**bcuc**  
British Columbia  
Utilities Commission

FortisBC Inc.

Application for a Certificate of Public Convenience and Necessity  
for the A.S. Mawdsley Terminal Station Project

Decision  
and Order C-6-23

**Figure 3: ASM Terminal Station Load Compared to N-1 Transformer Limits<sup>37</sup>**

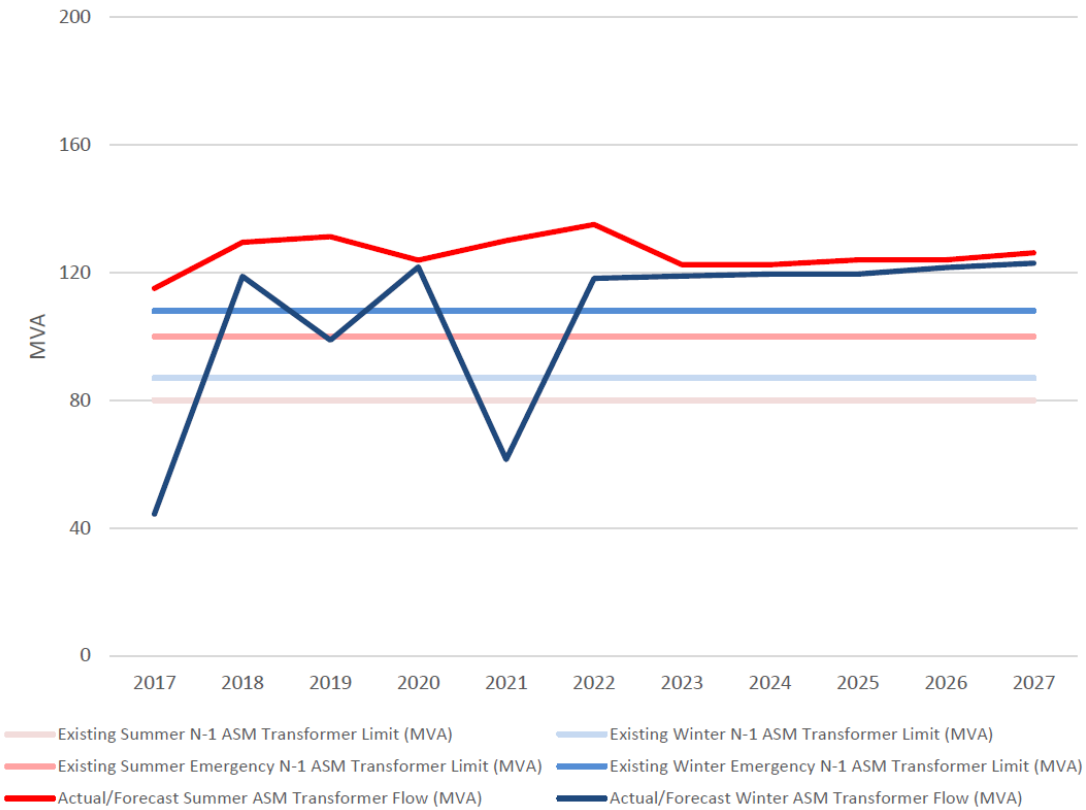
While the above Figure depicts ASM load exceeding N-1 transformer limits from 2017, FBC states that the load at the ASM Terminal Station has been exceeding N-1 transformer limits since at least 2014. Until completion of an assessment performed in 2019, FBC considered situations where load exceeded the ASM N-1 transformer limits to be either anomalous or temporary events for the purposes of transmission planning.<sup>38</sup> Through the 2019 assessment, and following the interconnection of a new industrial load in the Boundary area, FBC identified that the potential to exceed the N-1 ASM transformer emergency limits had increased in both frequency and size due to customer load growth.<sup>39</sup> FBC states that based on actual 2022 data, if one of the ASM transformers had failed and been non-operational through 2022, the remaining transformer would have been overloaded for approximately 23 percent of the year.<sup>40</sup> FBC states that the frequency of these high load situations will only become greater in the future, therefore necessitating the ASM Project at this time.<sup>41</sup>
